Supplemental Document of “Handling of Ki”
(OIL#34 & 1b_4)

Prepared by Ki TF Leader
10th WLTP IWG Meeting
14th ~ 16th APR 2015

Reference_1 : Loading Cycle and Distance

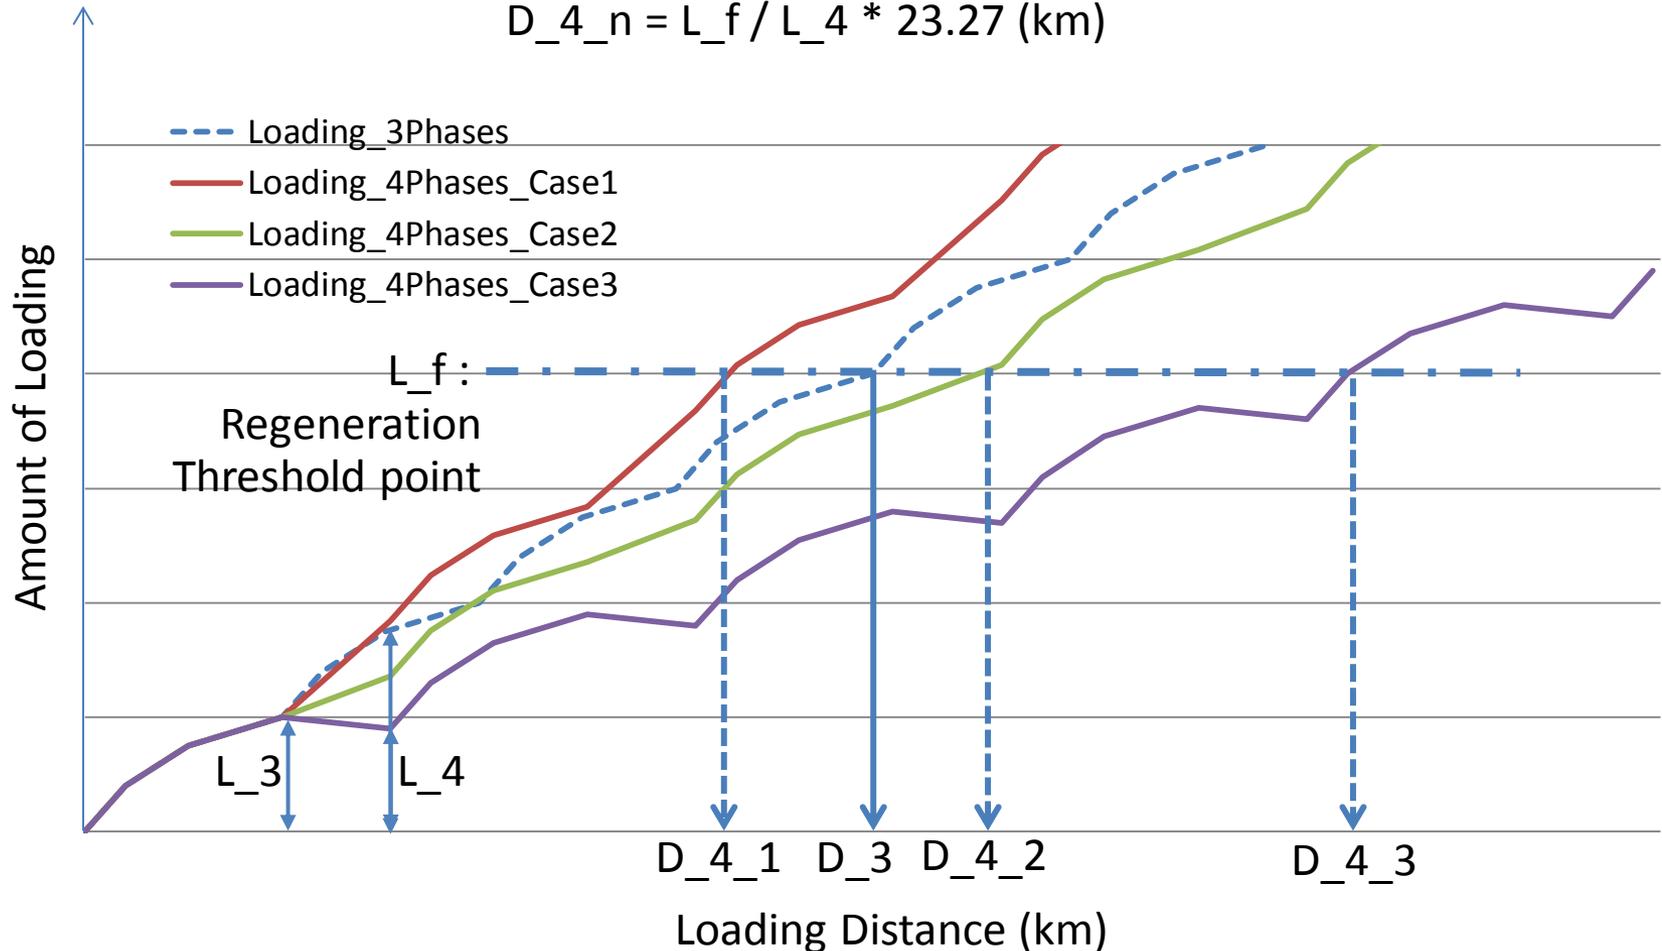
Cycle : loading cycle doesn't matter but amount of loading should be ensured up to "regeneration threshold point"

Distance : obtain based on calculation (D_3 is not always shortest distance)
